ORCHARD GARDENS REDEVELOPMENT

DEVELOPMENT FOR:  
FIRST COMMUNITY HOUSING  
245 W.WEDDELL DRIVE, SUNNYVALE, CA 94089

100%  
CONSTRUCTION  
DOCUMENTS &  
PERMIT SUBMITTAL  
ISSUED ON:  
07.14.2025

Misc. Plan  
Permit -  
Substantial  
Conformance  
Documentation

2 NORTH ELEVATION - BUILDING B2  
1/8" = 1'-0"  
MISC. PLANNING PERMIT ADJUSTMENT DRAWING

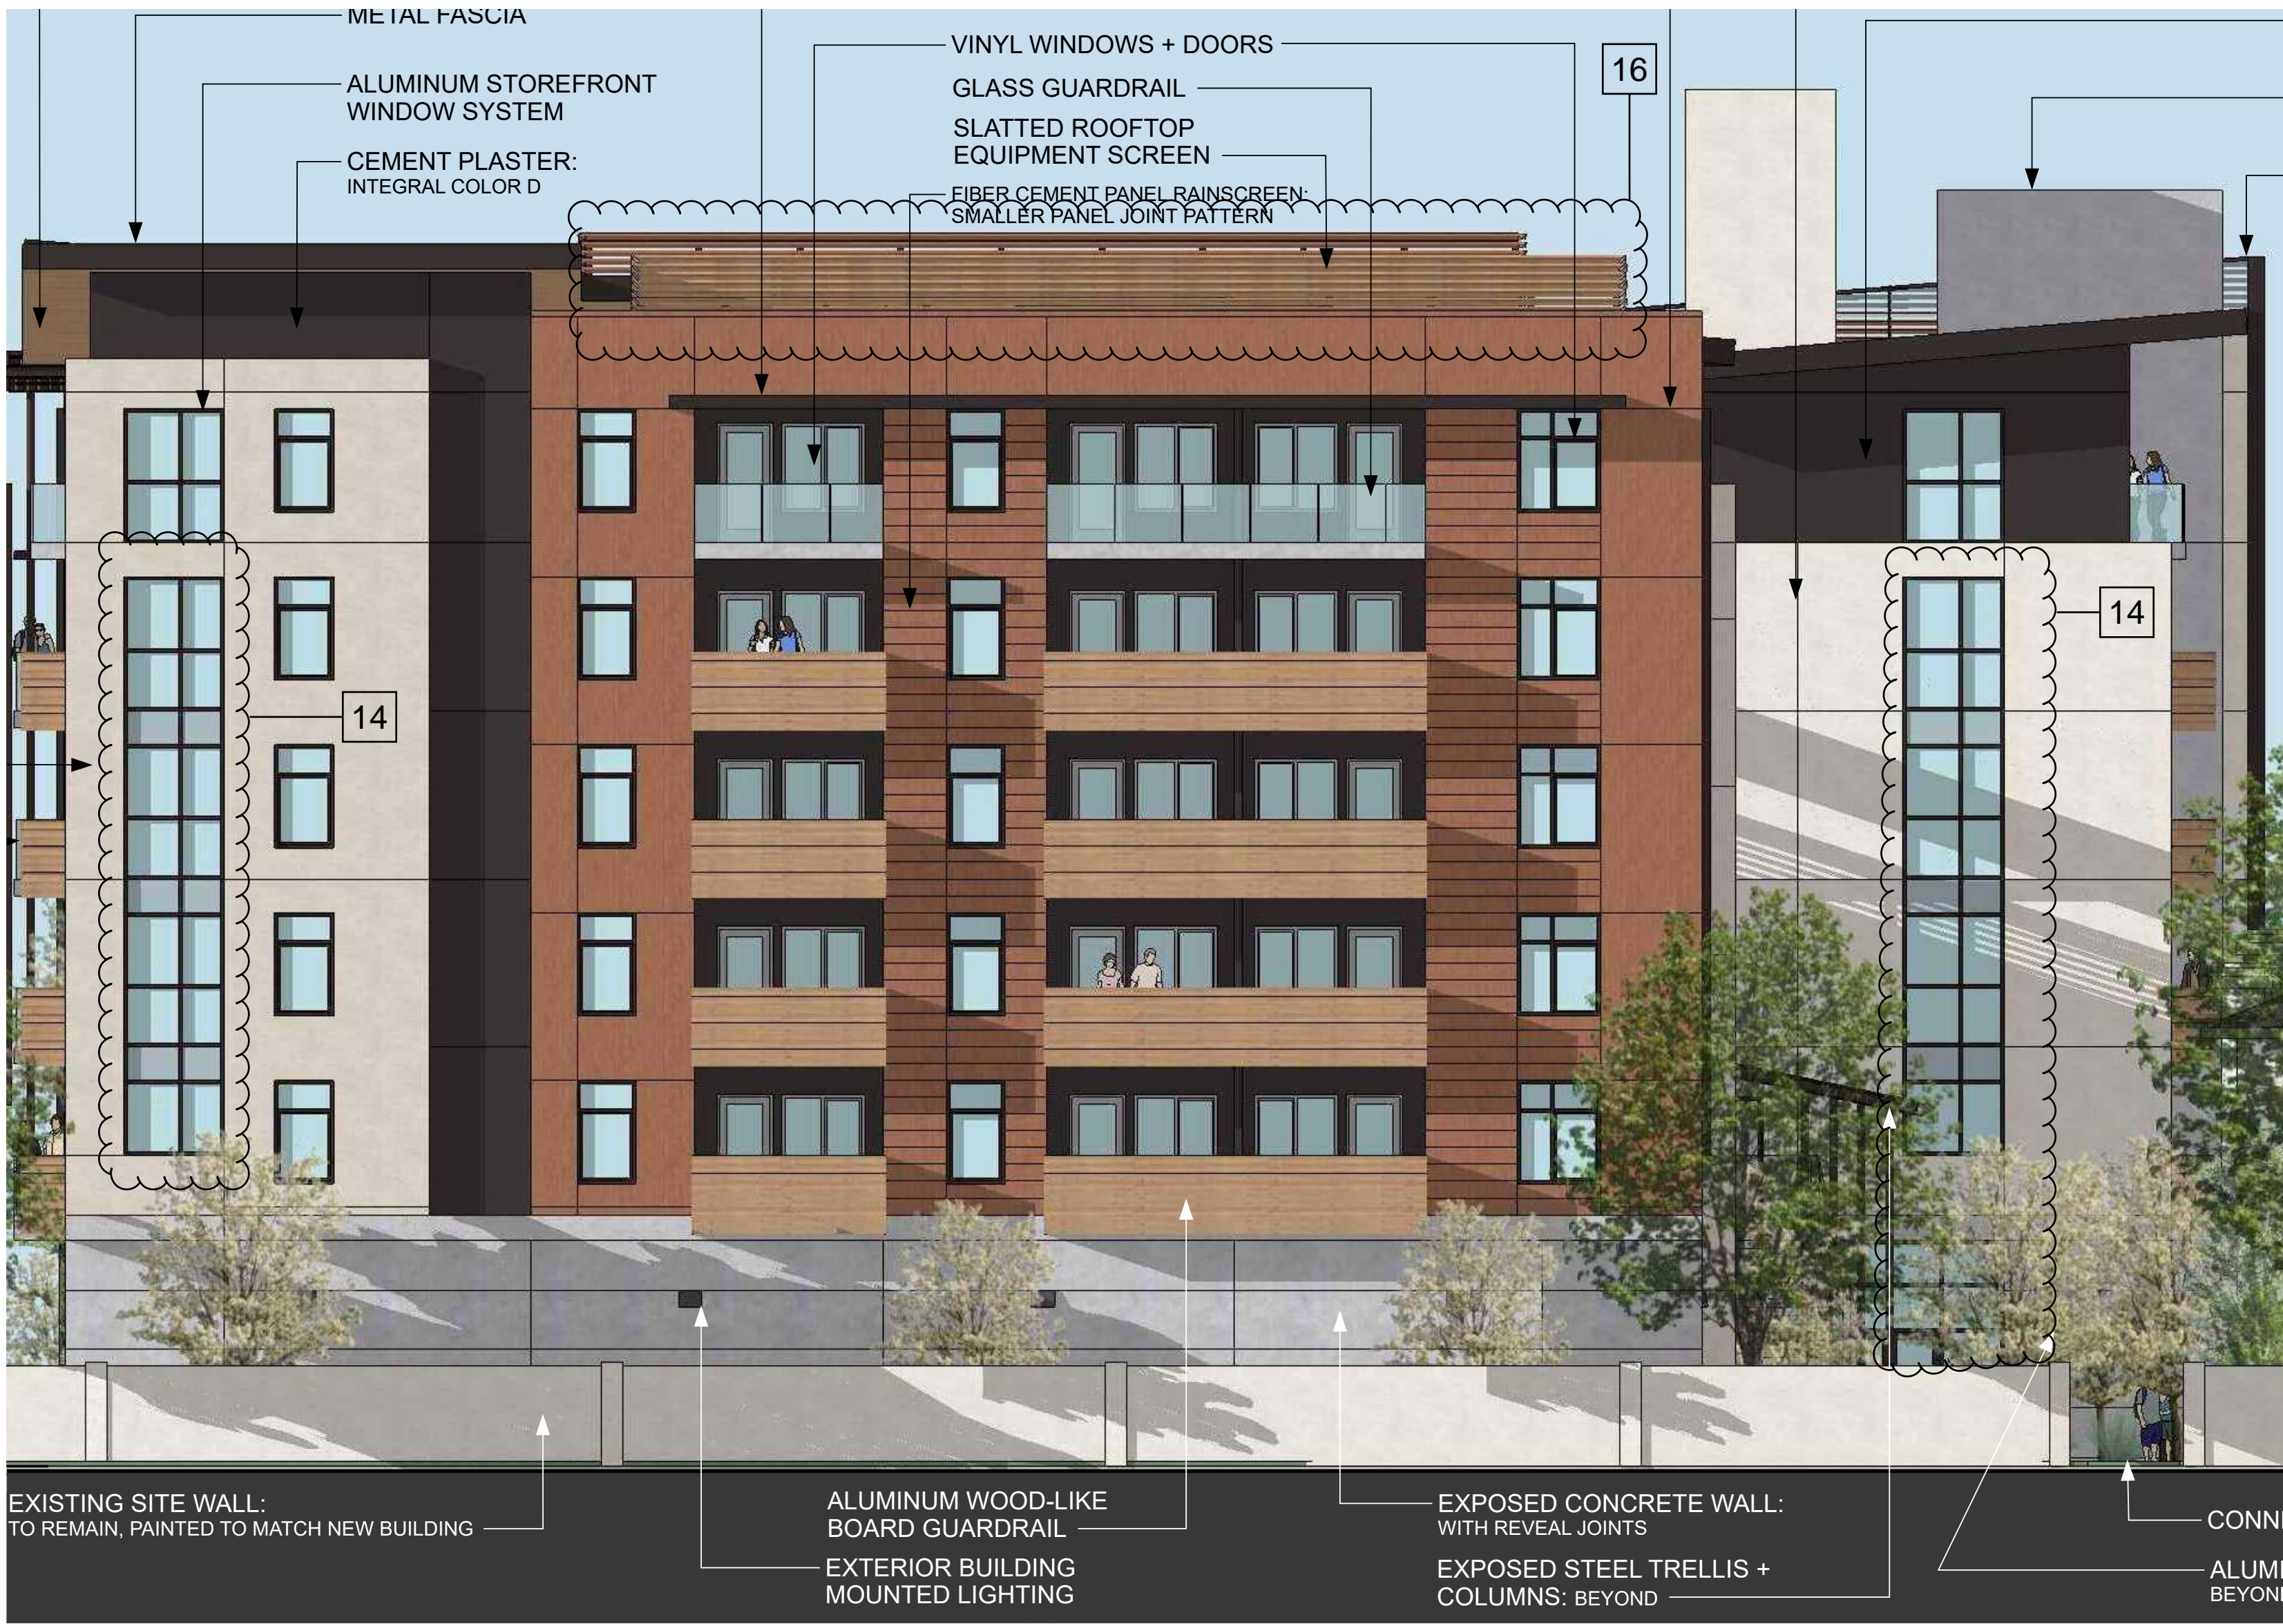
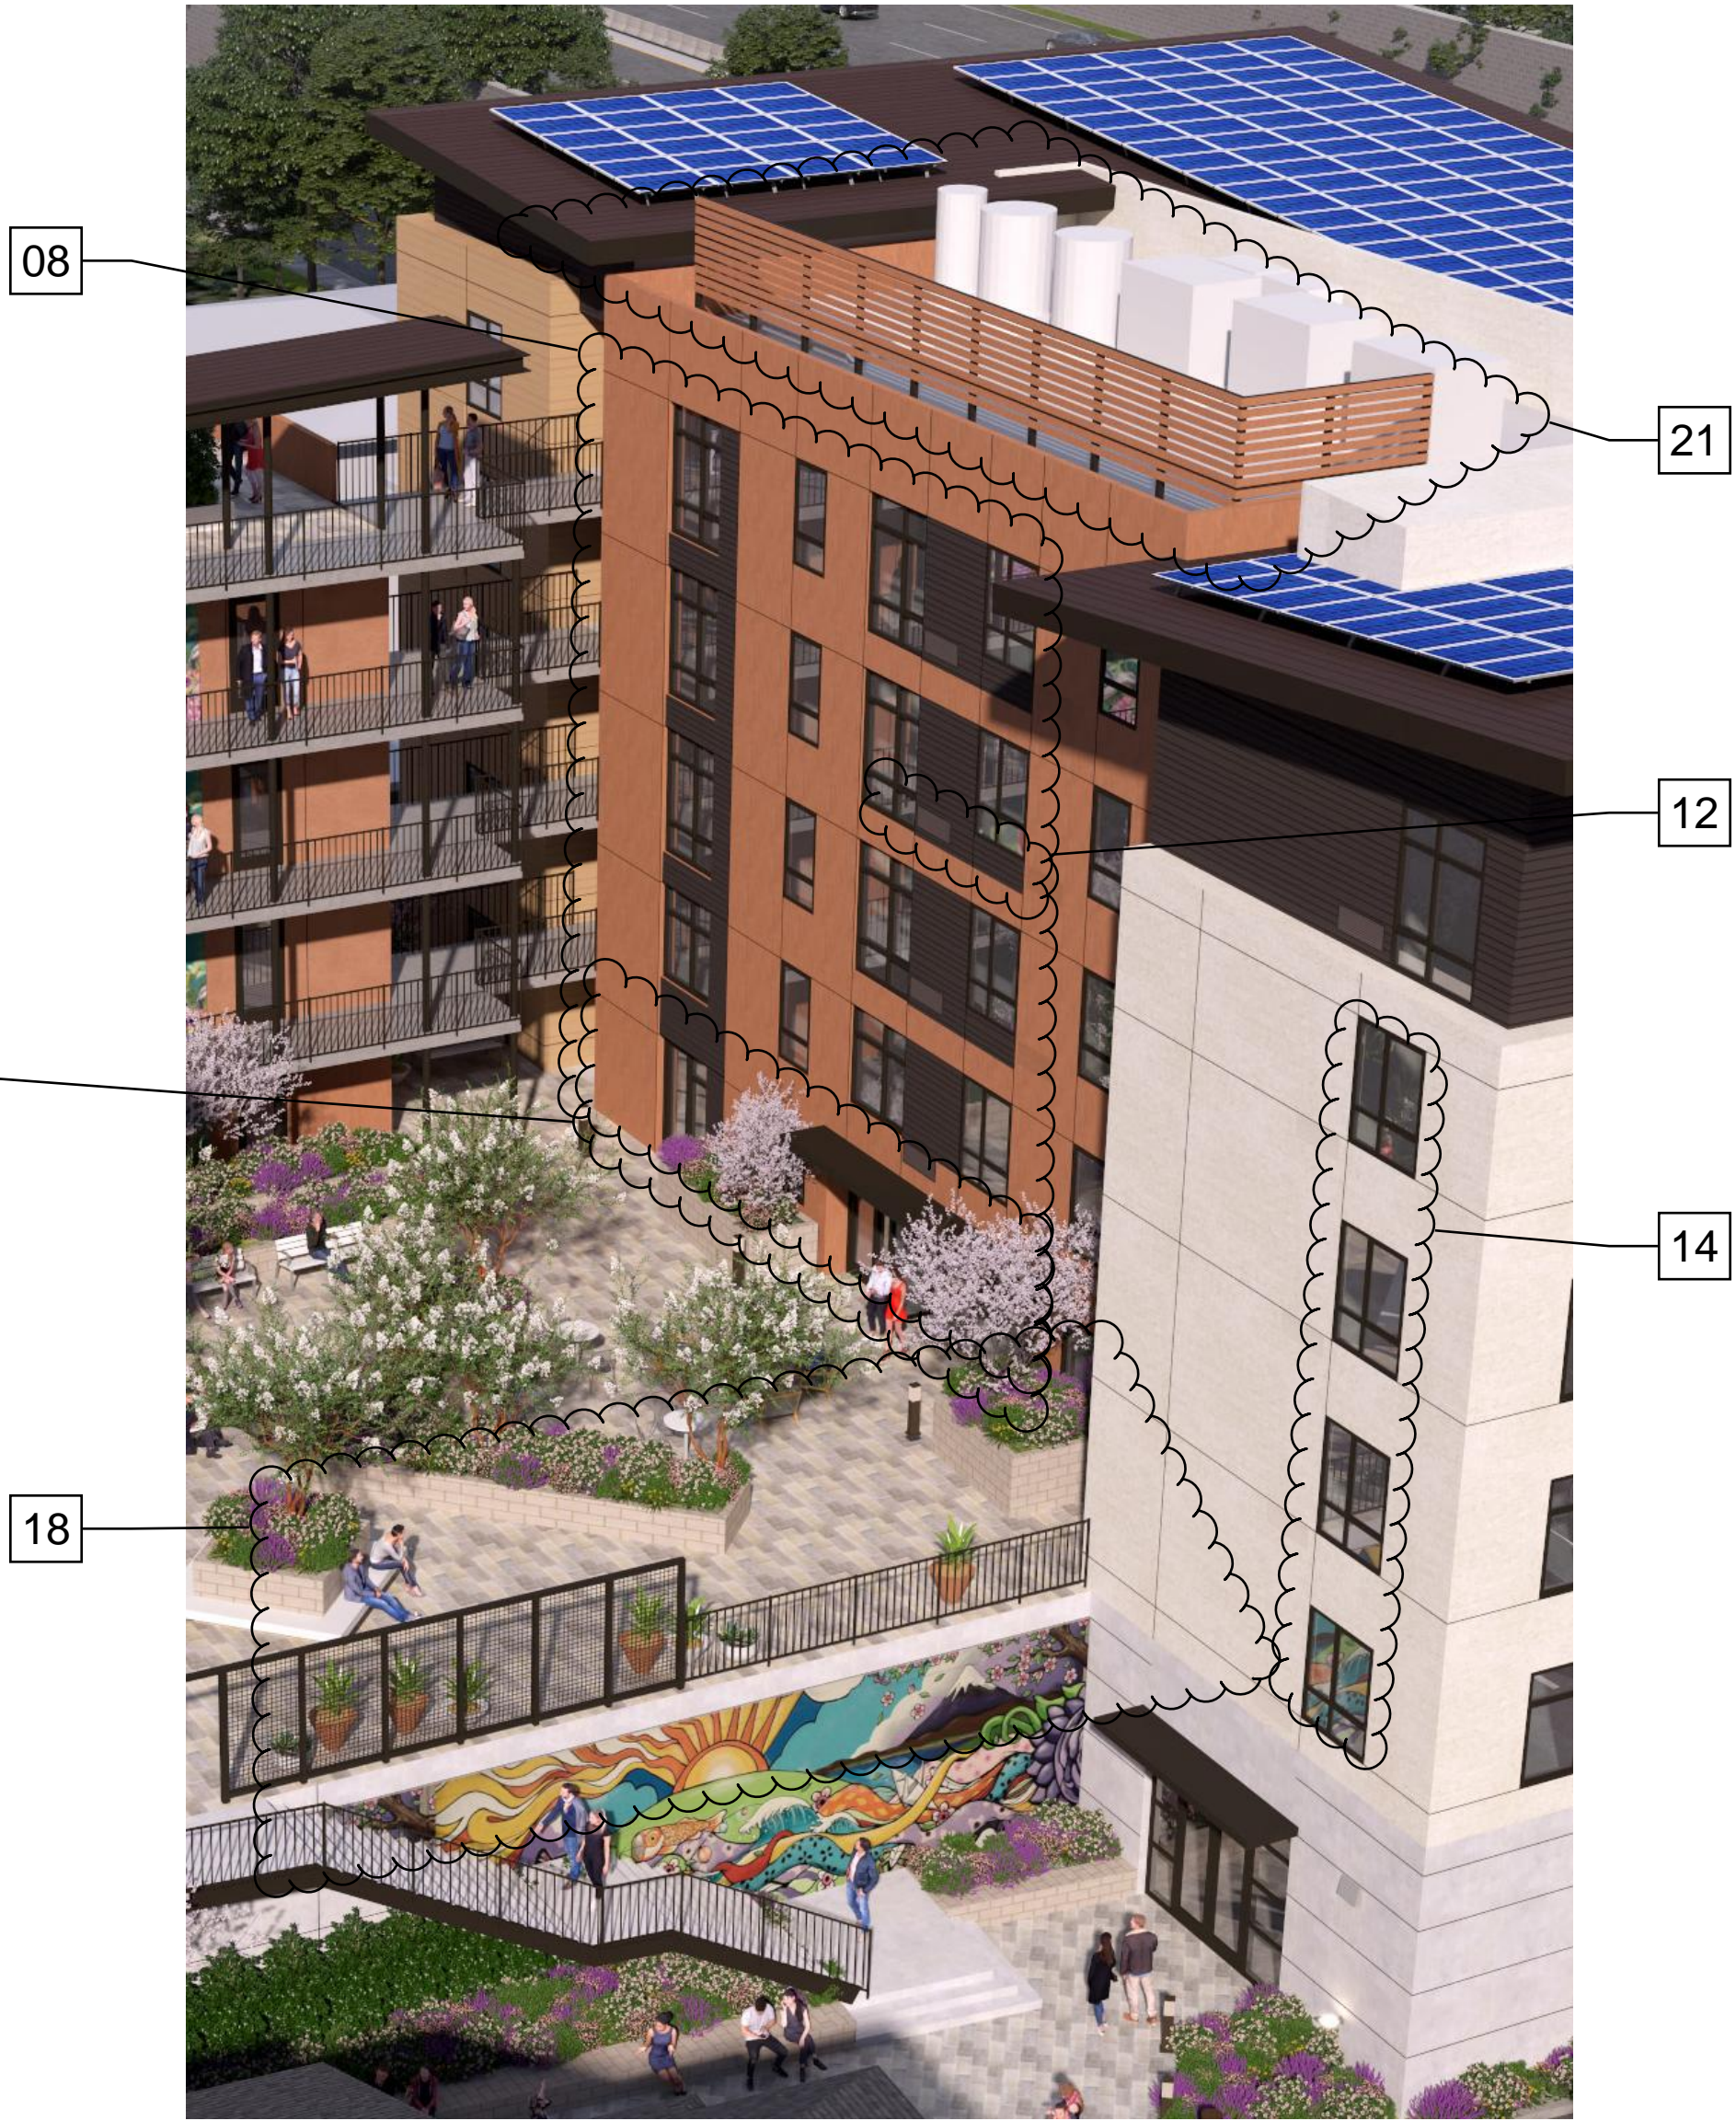
- SHEET NOTES**
- 03 \*COMMUNITY ROOM RELOCATION AND COURTYARD ROTATION
  - 08 REMOVED ALL BALCONIES.
  - 12 REPLACE CENTRALIZED VRF SYSTEM WITH PTHP, PROVIDE NECESSARY LOUVERS
  - 14 REPLACE STOREFRONT AND WINDOW WALL WITH PUNCHED OPENINGS
  - 16 REMOVED VRF EQUIPMENT AND ROOF EQUIPMENT SCREEN ON BUILDING B2.
  - 18 REMOVAL OF STEEL CANOPY OVER EXTERIOR STAIR
  - 21 ROOFTOP EQUIPMENT REDUCED DUE TO CHANGE FROM VRF TO PTHPS

1 STREET FRONTAGE RENDERING - PLANTER/SEAT WALL UPDATES  
1/8" = 1'-0"  
MISC. PLANNING PERMIT ADJUSTMENT DRAWING

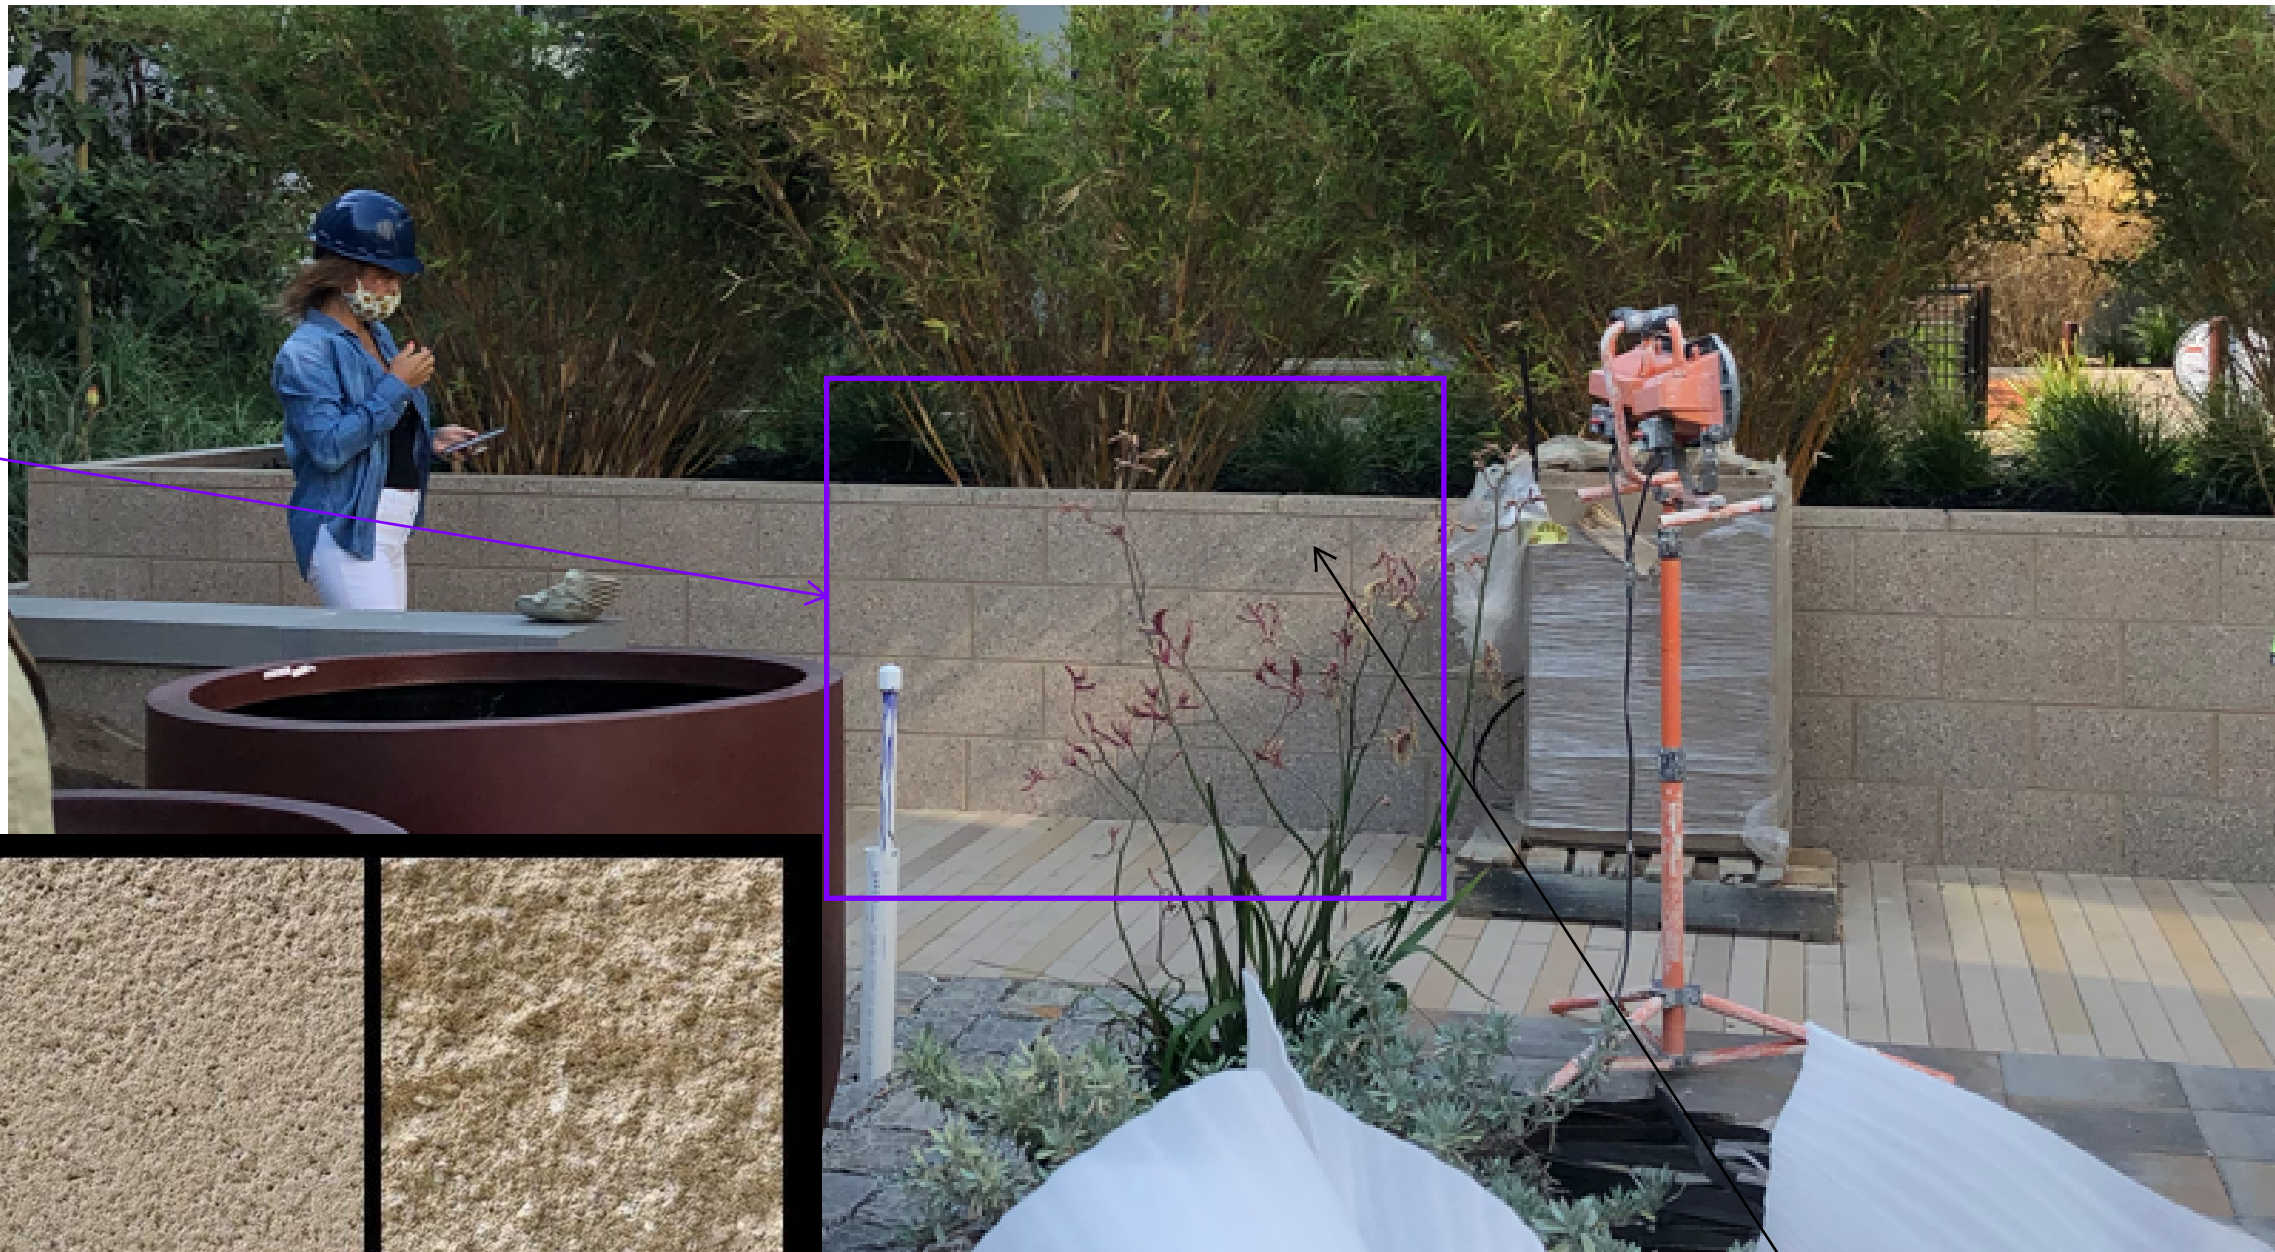
PROPOSED CMU PLANTER WALL MATERIAL, COLOR, STACKING AND CAP FOR RAISED PLANTERS ALONG THE STREET FRONTAGE, PEDESTRIAN CONNECTION AND COURTYARD. THE CMU PLANTER WALLS PROVIDE A DURABLE AND AESTHETICALLY PLEASING SOLUTION ADDING TEXTURE AND COLOR TO THESE AREAS.

- 13 PLANTER WALL MATERIAL AT FRONT ELEVATION CHANGED FROM WOOD BOARD OVER CONCRETE TO CMU
- 22 REMOVAL OF DECORATIVE STEEL TRELLIS OVER ROOF GARDEN
